### REMARKS

Claims 1-35 and 37-39 remain pending in the application, with claims 1-29 and 34 having been withdrawn from consideration. Claim 36 has been canceled without prejudice or disclaimer, and Figures 1, 13, 14, 15, 16, 17, 18, 19, 21, 22, 26, 28, and 29 as well as claims 30-33, 35, and 37-39 have been amended without introduction of new matter. Favorable reconsideration is respectfully requested in view of the above amendments and the following remarks.

FIG. 13

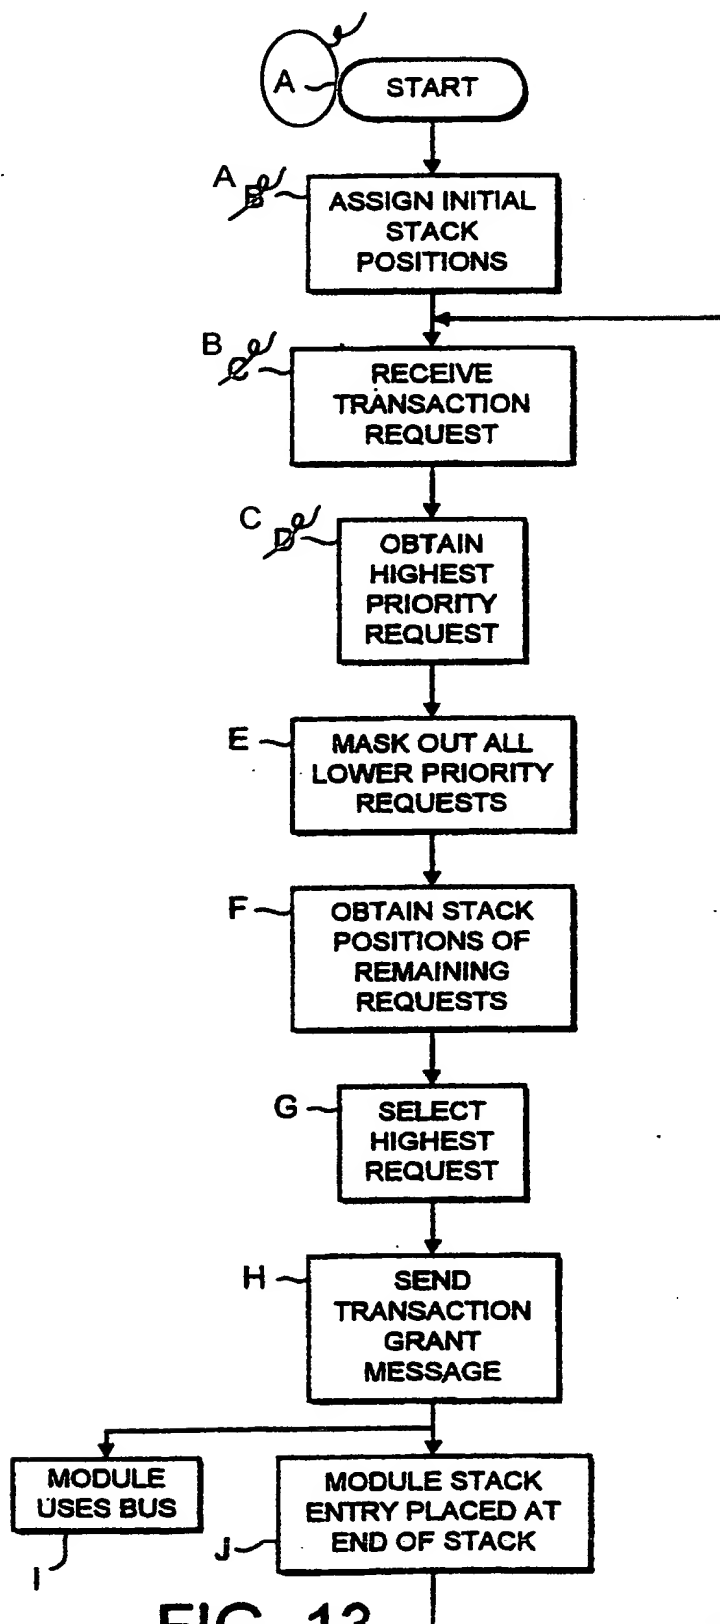
Figures 1, 13, 14, 15 16, 17, 18, 19, 21, 22, 26, 28, and 29 were objected to as failing to comply with 37 CFR §1.84(p)(5) because they include reference signs not mentioned in the description. In addition, Figure 13 was also objected to as failing to comply with 37 CFR § 1.84(p)(4) because:

- the reference character “A” has been used to designate both “start” in Figure 13 and “assign initial stack positions” on page 17, lines 15-17;
- the reference character “B” has been used to designate both “assign initial stack positions” in Figure 13 and “receive respective transaction requests” on page 17, lines 22-23; and
- the reference character “C” has been used to designate both “receive transaction request” in Figure 13 and “determine highest priority level” on page 17, lines 28-30.

With respect to Figure 13, this has been amended to delete the reference sign “A” from the block labeled “START”, and to re-label the blocks “B”, “C”, and “D” as “A”, “B”, and “C”, respectively. This cures the defect of reference sign “D” not being mentioned in the specification. This amendment also cures the above-mentioned defect of having some reference signs referring to one thing in the figure and another thing in the description. As to reference sign “H” in Figure 13, the Office’s attention is directed to the specification at page 18, lines 12-13, where this reference sign is already mentioned. Thus, no further amendment is necessary.
